**Proposed Plan Change 9 to the  
Regional Resource Management Plan**

**Supplementary evidence of Maurice Wayne BLACK on behalf of  
Te Taiwhenua o Heretaunga  
Re: Appendix 11 to the s42A report**

**September 2021**

32. **Figure 1:** Heretaunga groundwater monitoring wells for the months of July and August. Source – HBRC SOE reporting July 2021 and August 2021.

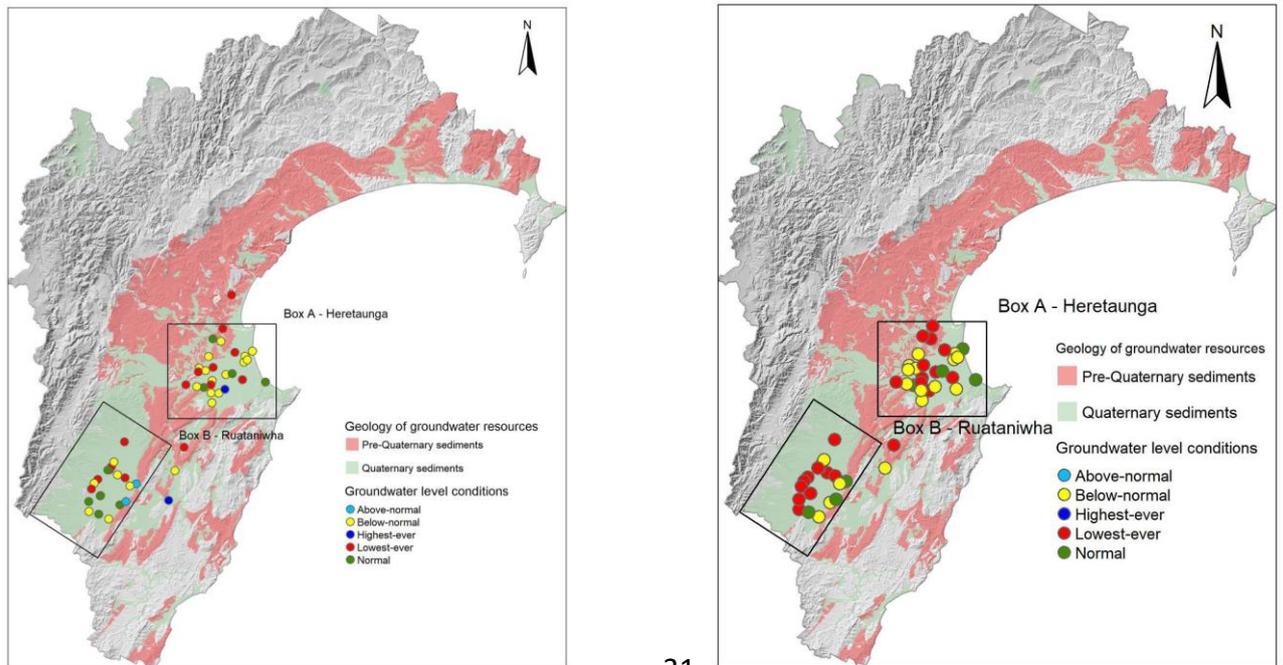
33. The most recent SOE monitoring of groundwater in Heretaunga wells show lowest levels ever recorded for the months of July and August, occurred in 2021, meaning they have not yet recovered from the last season’s abstraction, at the start of the new irrigation season.
